**KNOXVILLE HISTORIC ZONING COMMISSION
STAFF REPORT - CERTIFICATE OF APPROPRIATENESS APPLICATION**

PROPERTY LOCATION: 712 Gratz St. /
Parcel ID 94 D E 033

FILE NO.: 9-H-19-HZ

MEETING DATE: 9/19/2019

HVAC Unit Installation

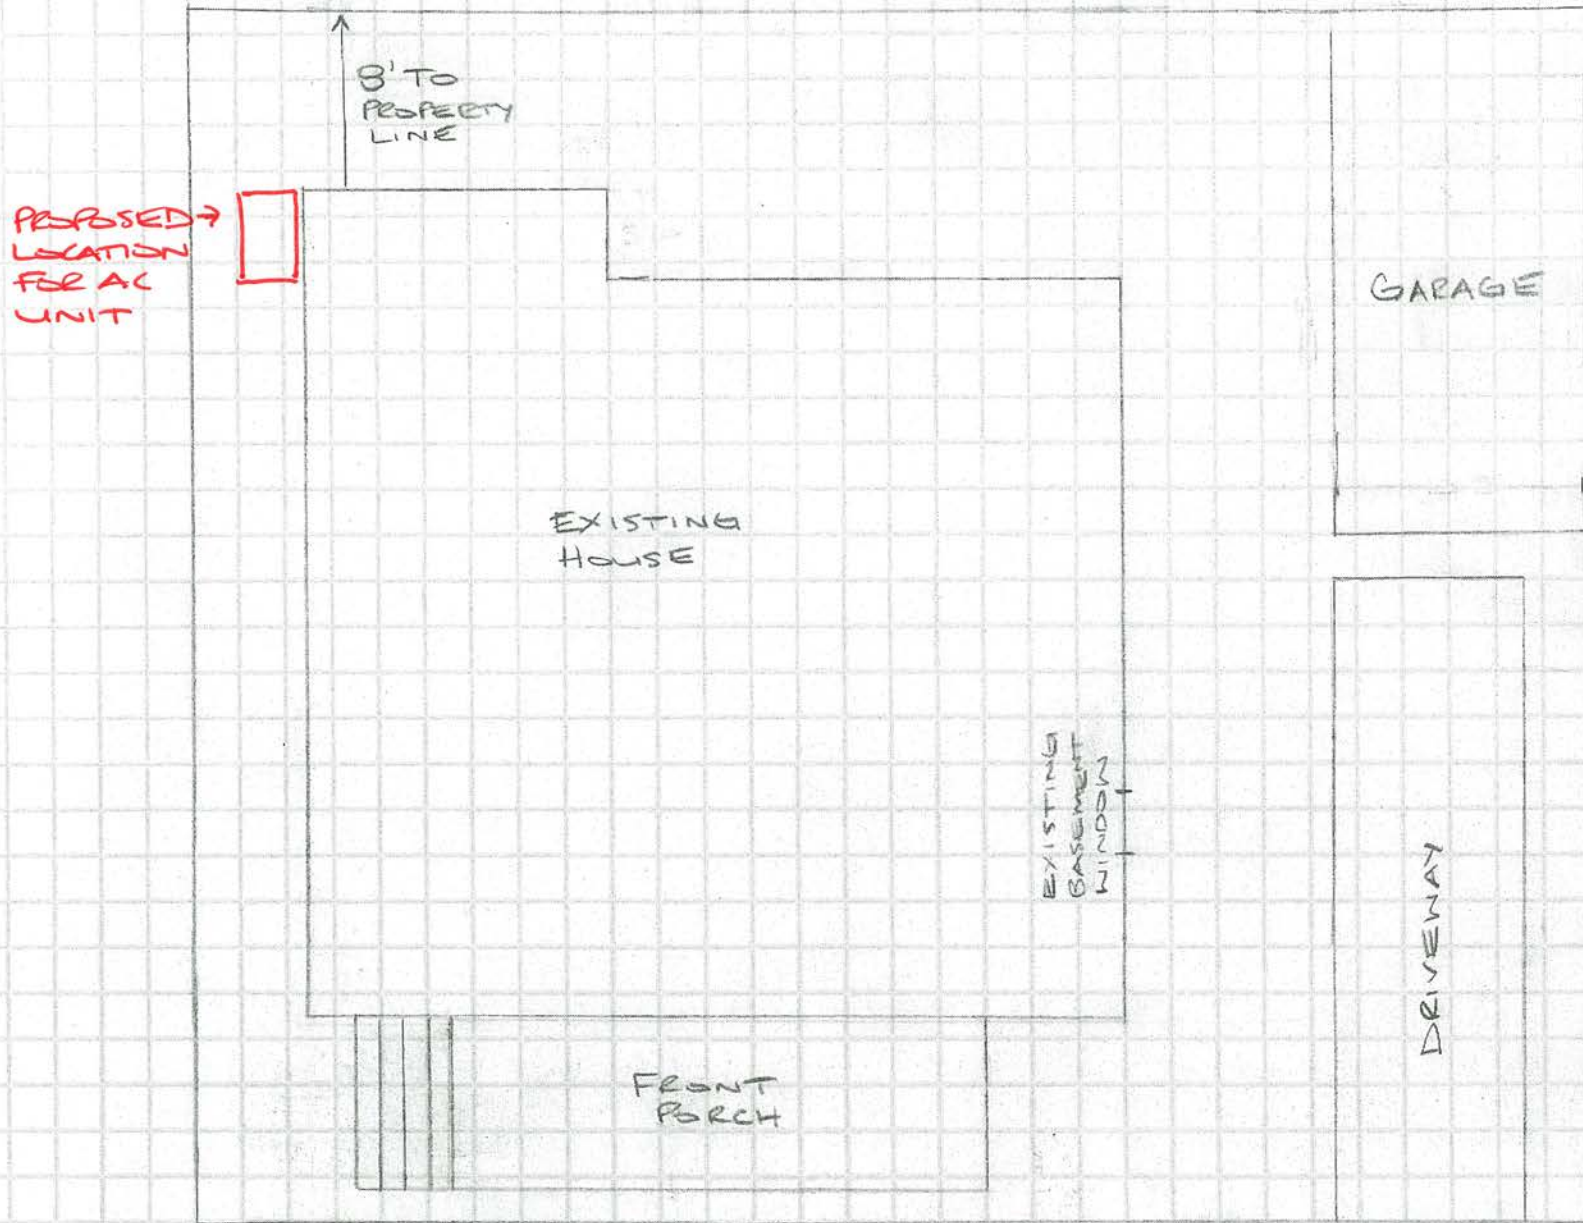
2. The proposed placement of the HVAC unit towards the rear of the north side elevation is appropriate. Guidelines recommend that they should be screened with shrubbery or fencing.

Staff recommends approval of the following: installation of basement entry doors; replacement in-kind of wood porch elements; HVAC installation, with the condition that shrubbery or fencing be installed to screen the unit; the rear addition, with the condition that the addition be differentiated from the historic structure via a small offset, a change in siding, or other design tactic; porch stair installation, with the condition that the stairs receive a handrail and guardrail to meet codes. Revised design of the rear addition and the porch stairway to be reviewed and approved by staff.

Rear Addition

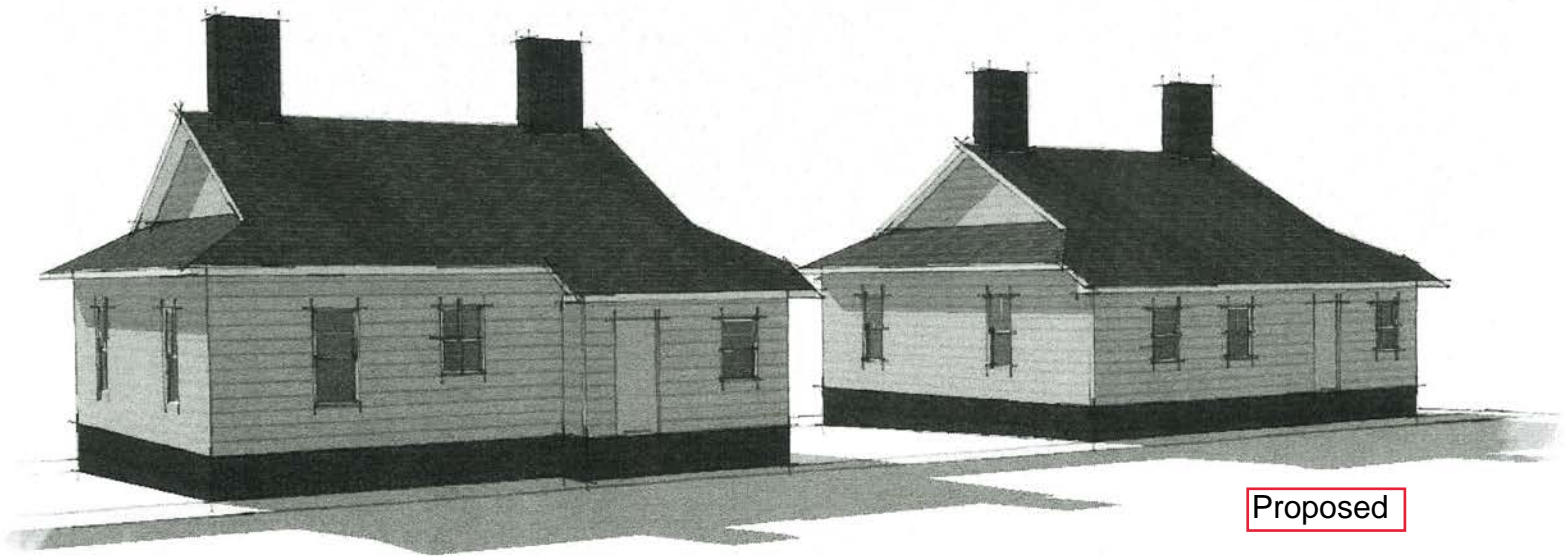
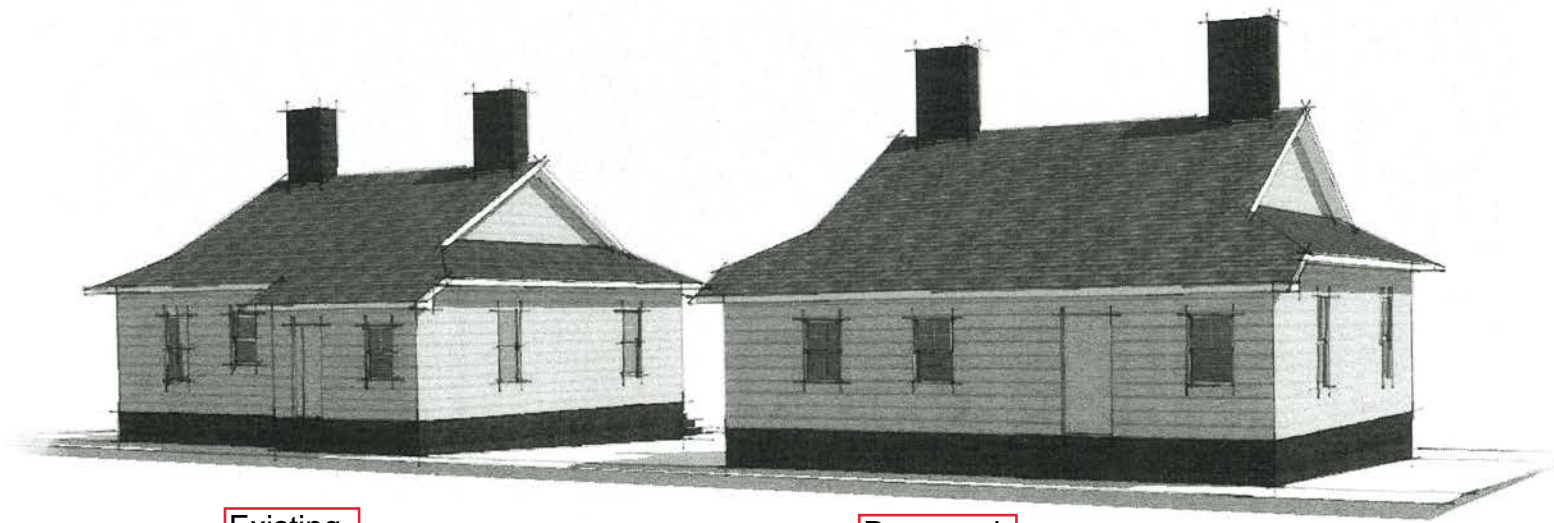
3. The size, scale, and location of the proposed rear addition is appropriate.

4. Guidelines recommend that new additions are installed in a manner that makes clear what is historic and what is new, avoiding duplicating the exact form, material, and detailing of the historic building in the new addition. The proposed addition is not presently differentiated from the historic structure, whether via a small offset or a change in siding.

Basement access hatch

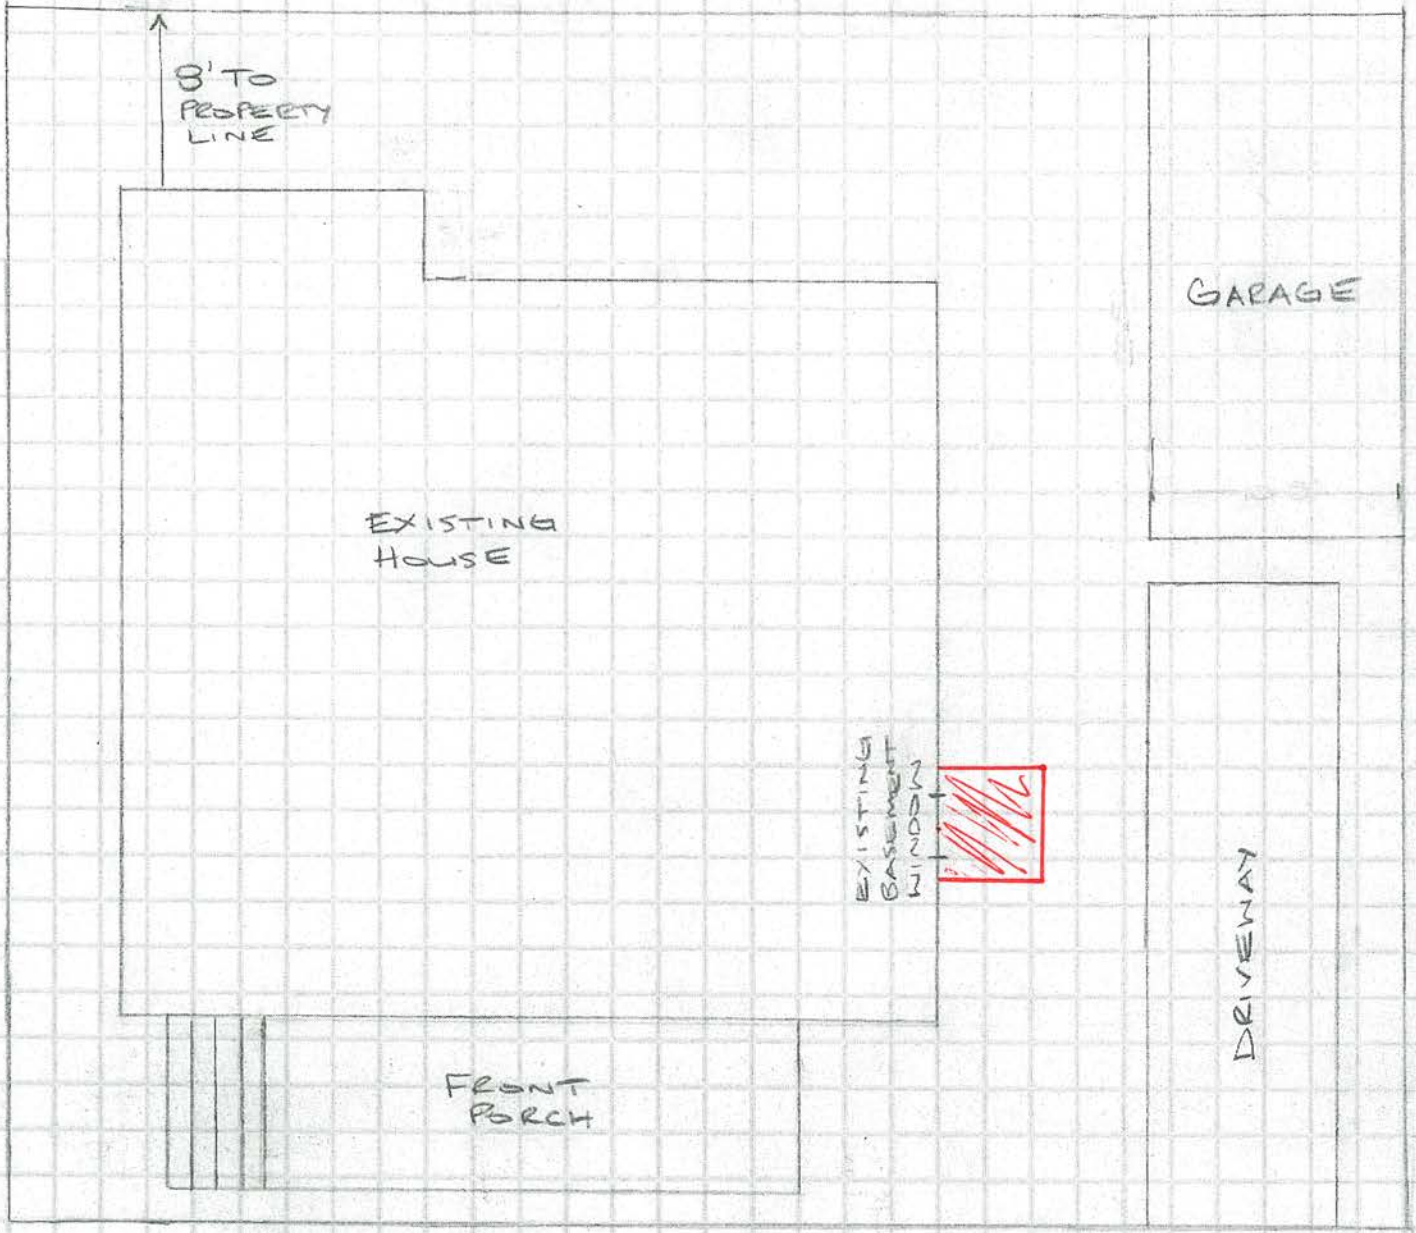
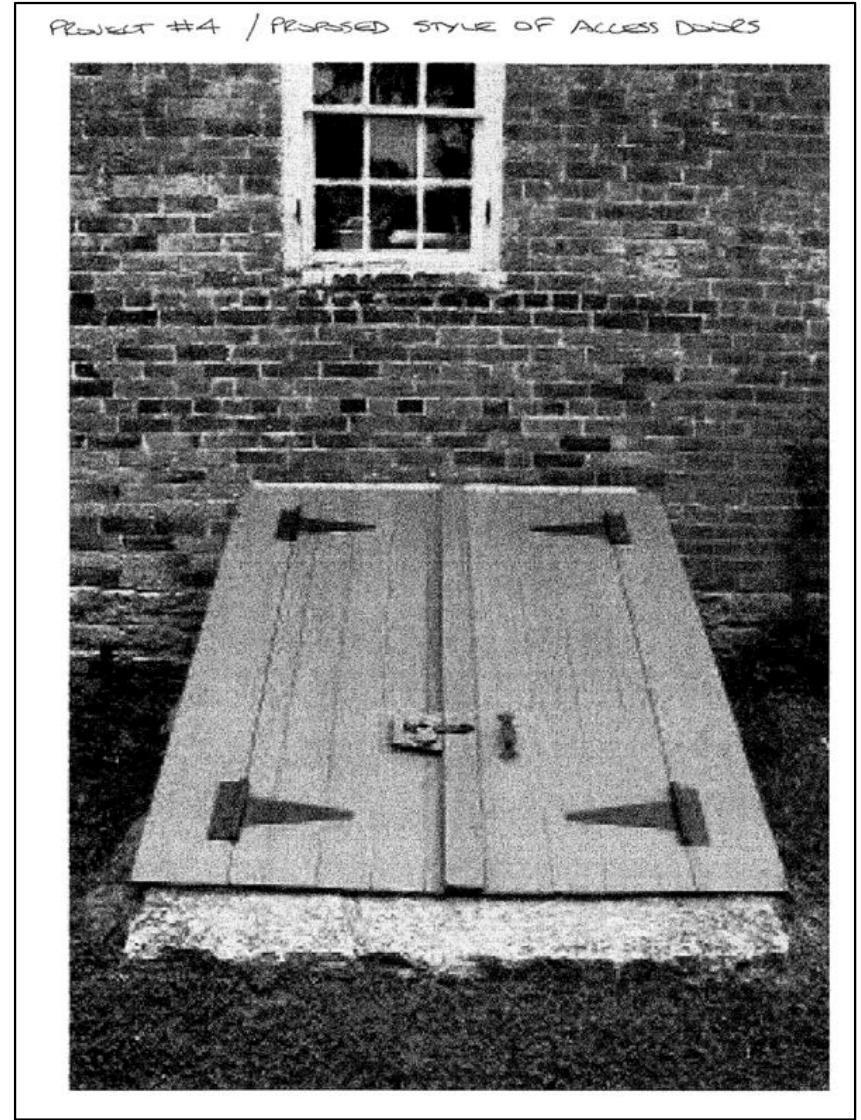
5. The basement access hatch is small in size and will not detract from the historic integrity of the house.
6. Per 2018 IRC, if a stairway includes four or more steps, a handrail is necessary for safety. A guardrail is also required if stairs are located at 36" above the groundline. The south side of the porch is above 36" tall and would require a guardrail of at least 34" tall. The top of the guardrail could serve as the handrail and be between 34" and 38" tall. An exact mirror of the north elevation stairway would create design challenges with the required guardrail being visibly taller than the original porch balustrade.
7. Replacement in-kind of wood porch columns and any rotted sections of flooring is appropriate.
8. There is not a precedent for approval of fiber cement board siding as a full replacement for existing siding on a historic house in the neighborhood.
